Preliminary /
Final
Drainage
Report

Koinonia Ranch

January 28, 2022

PCD File No. SP-21-004

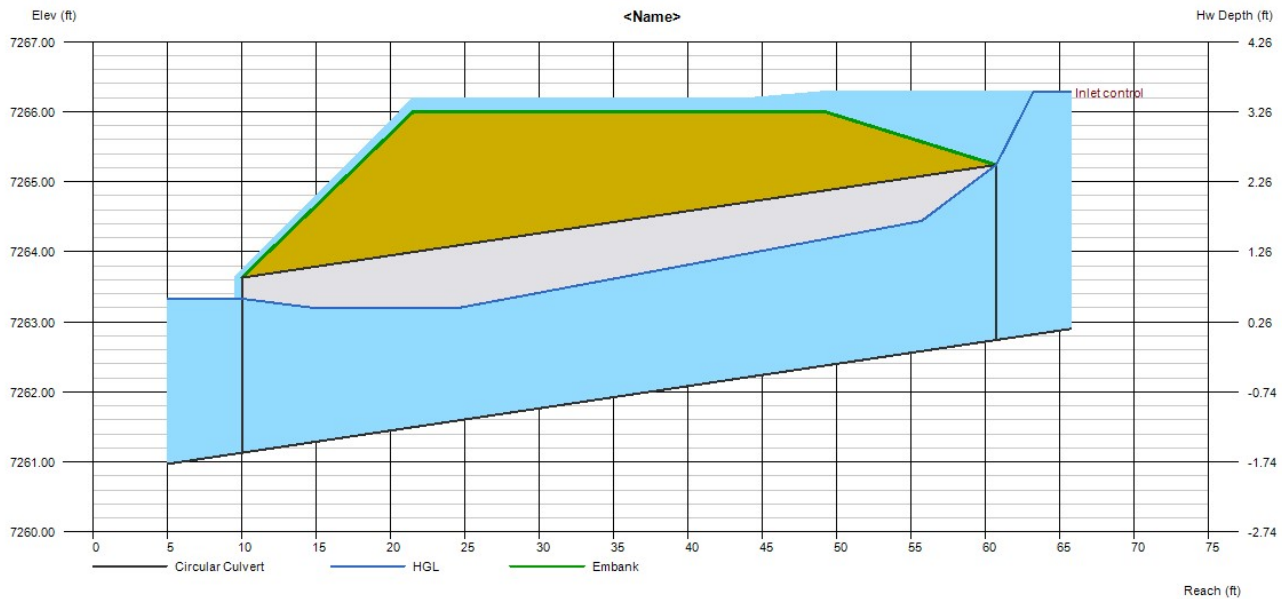
Please provide riprap for this outlet.

MVE PROJECT 61148
MVE DRAWING EX-DRN

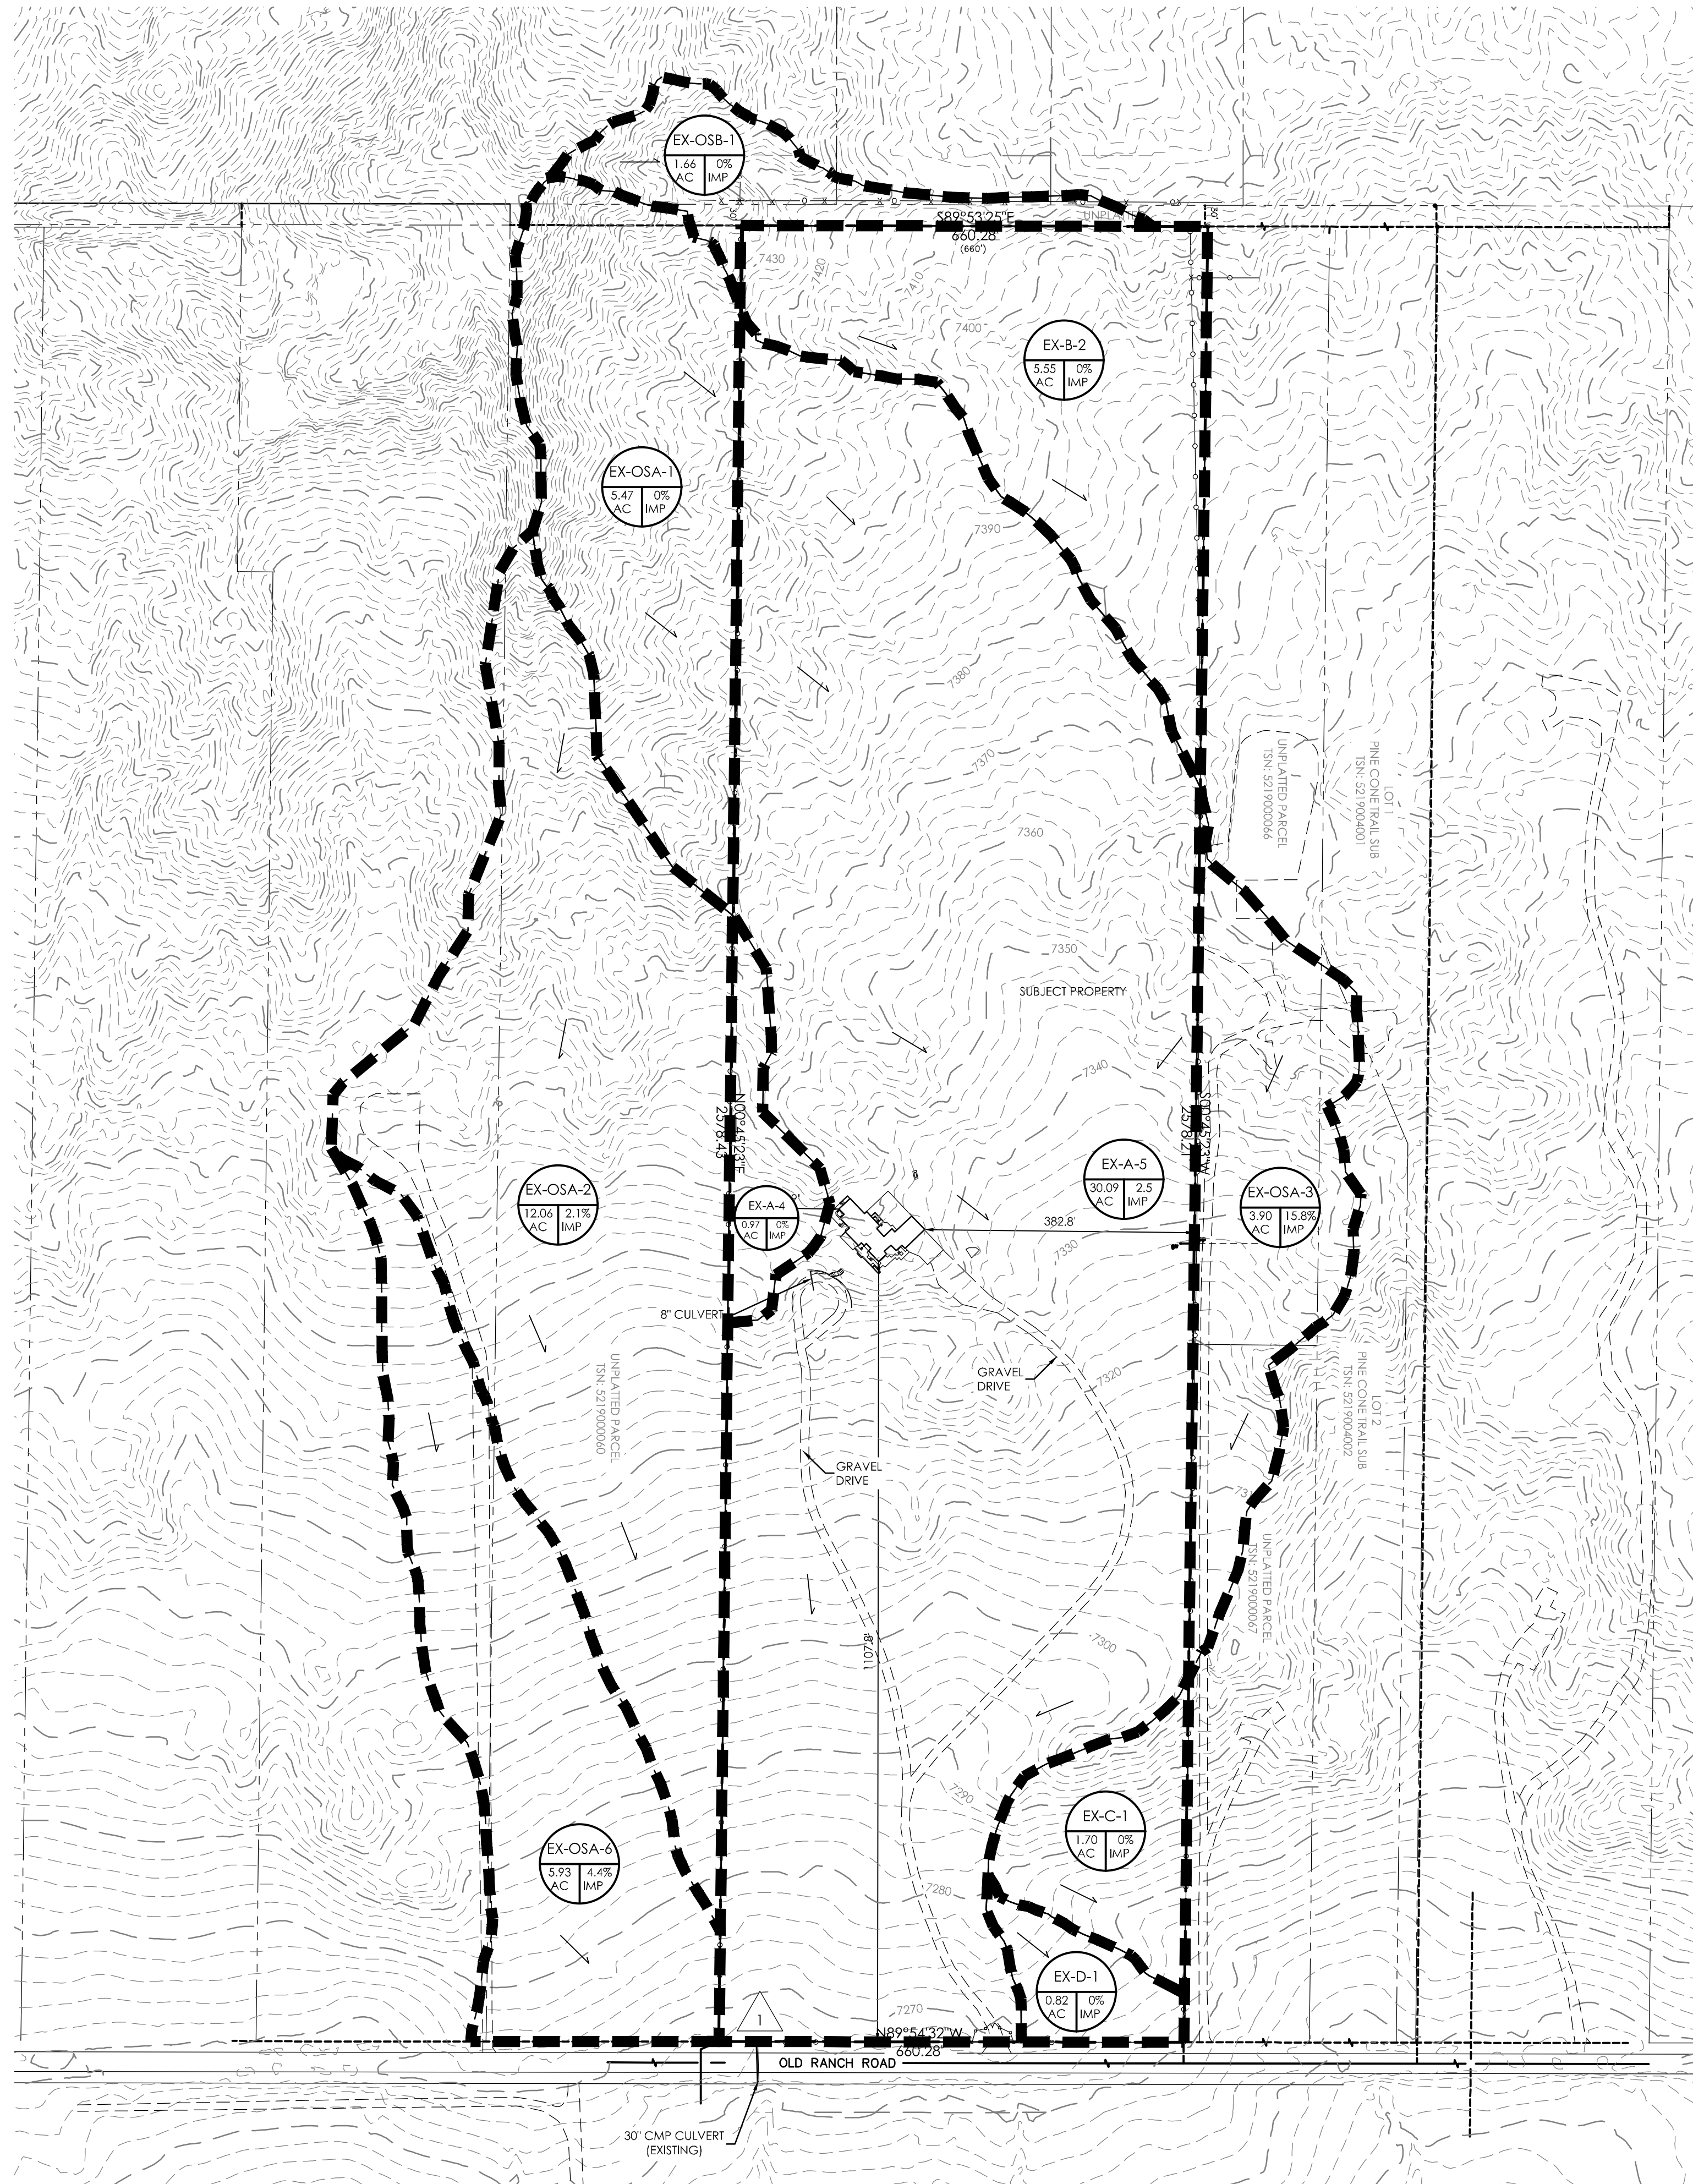
Show path of time of concentration.

MVE PROJECT 61148
 MVE DRAWING PP-DRN

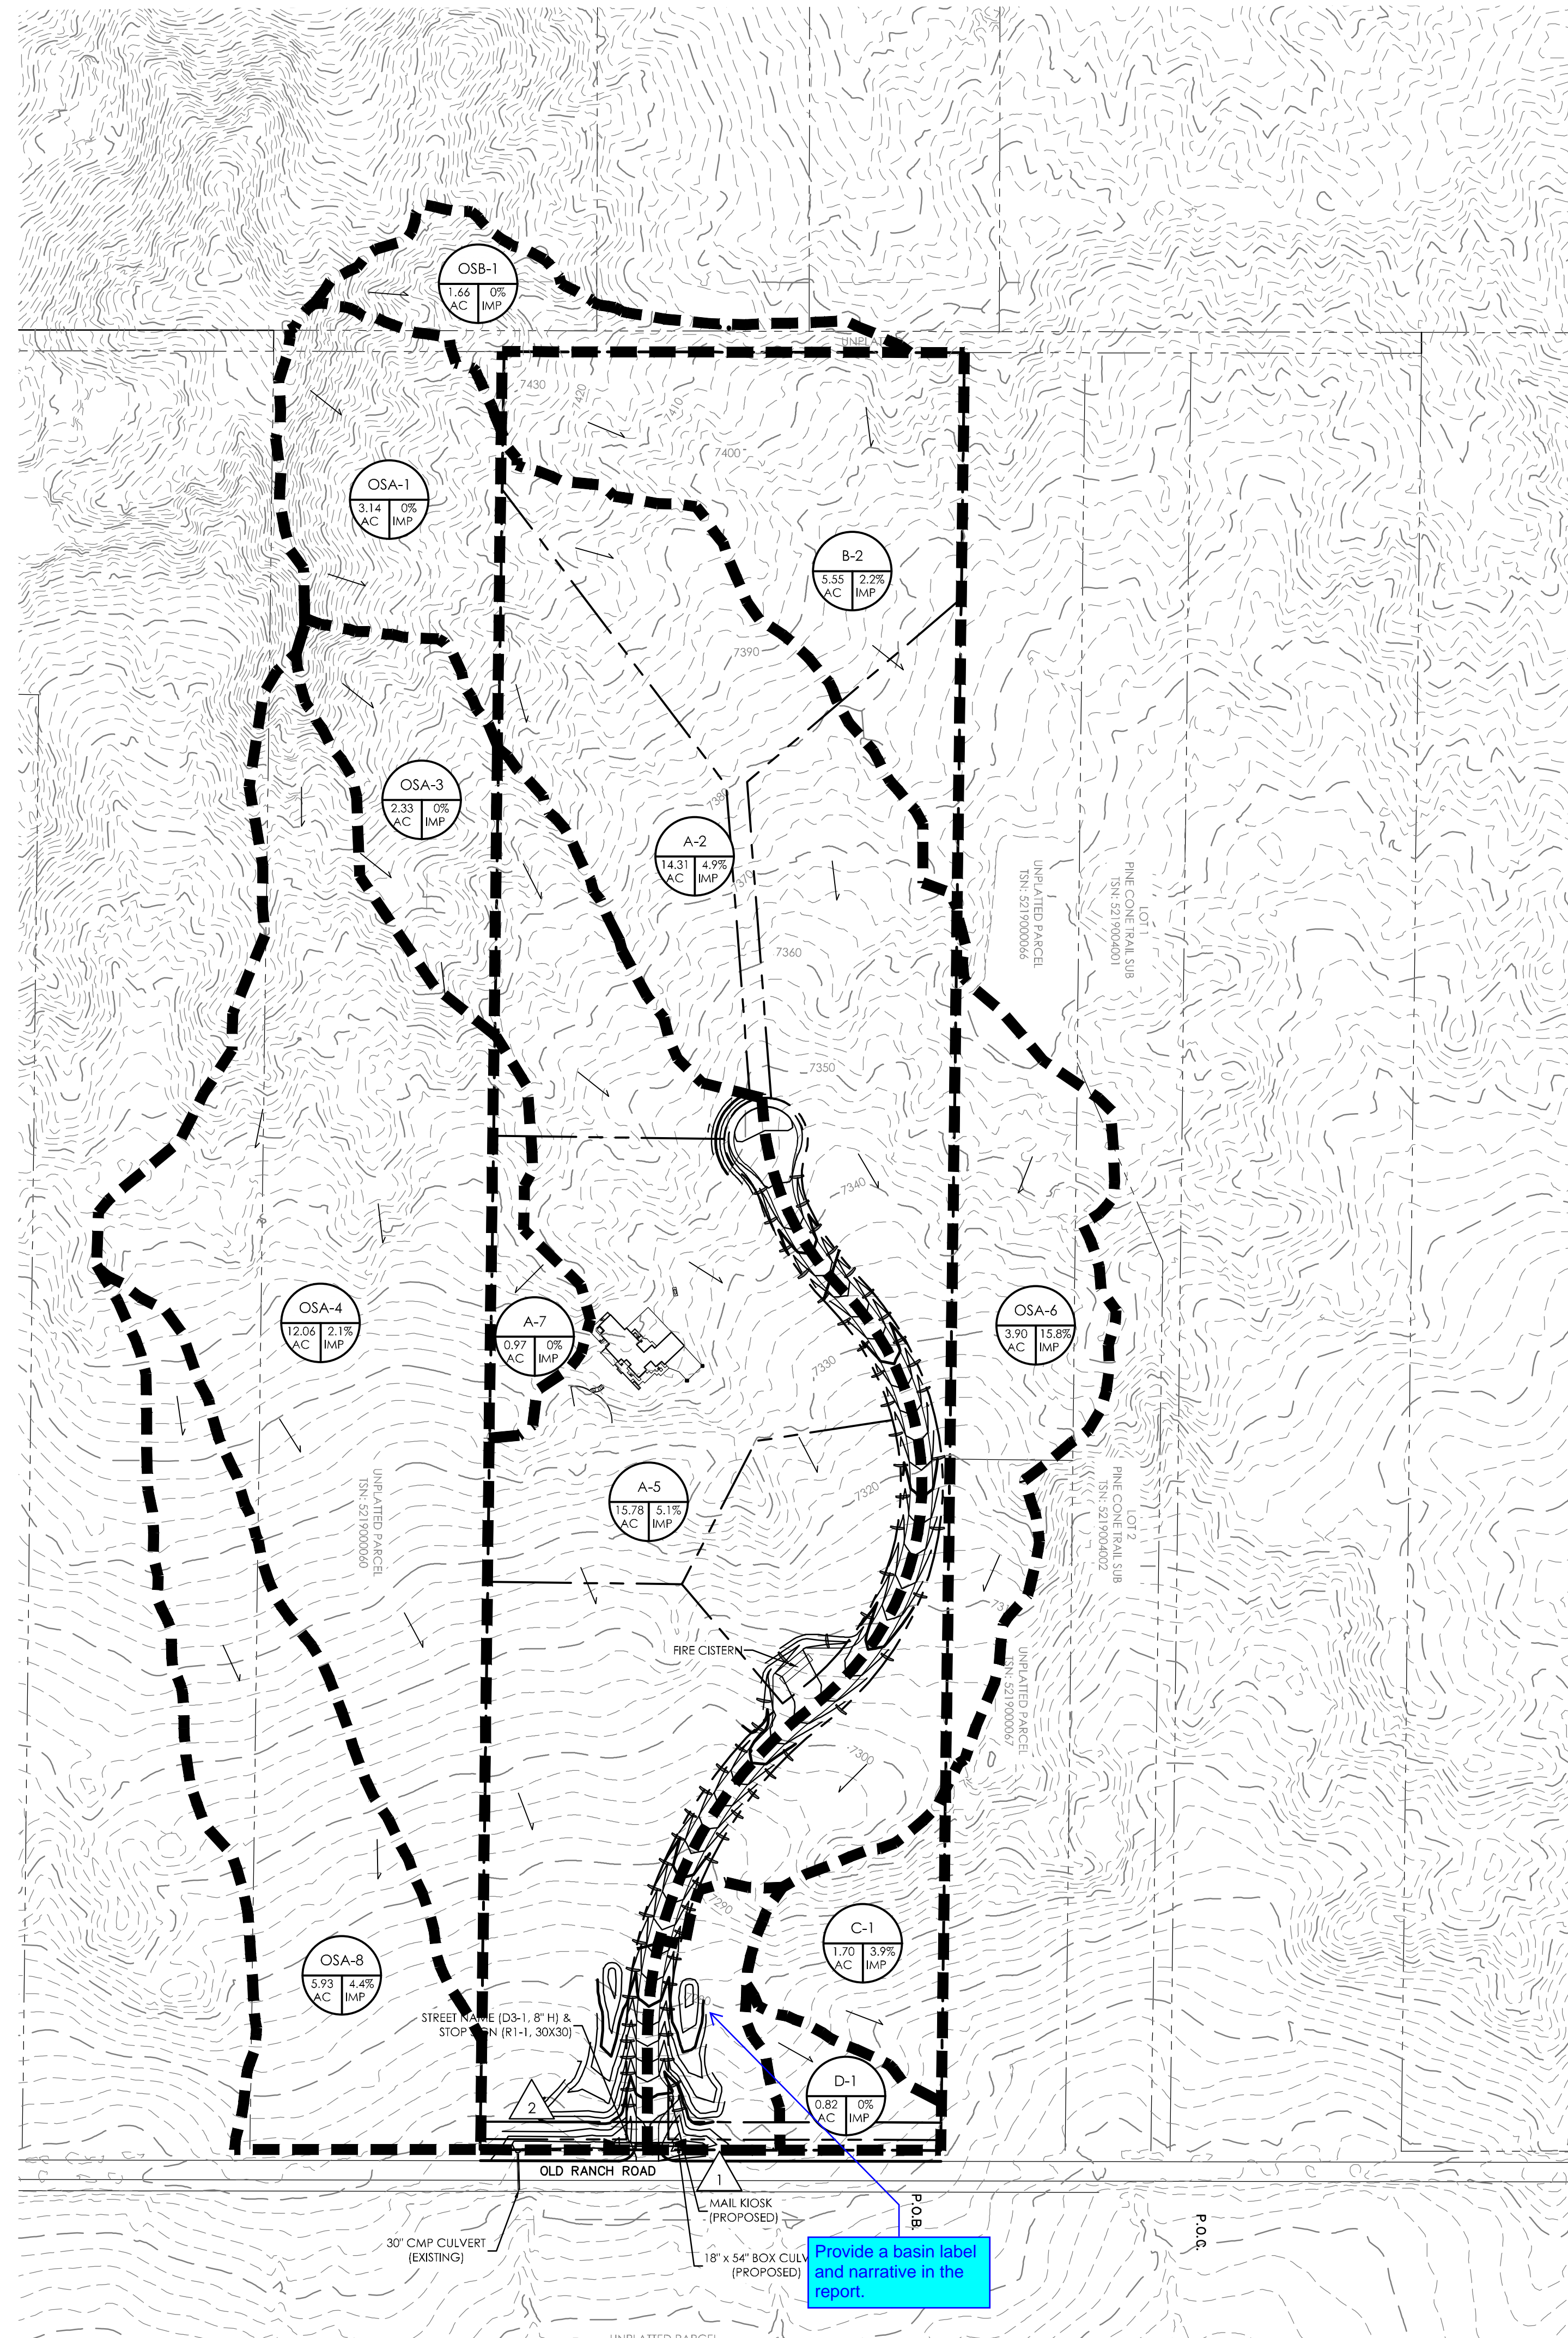
Per ECM 3.2.4 drainage easements are required where runoff exceeds 15 cfs. Outline drainage easements and reflect dimensions on final plat drawing.

Show path of time of concentration.

Provide a basin label and narrative in the report.
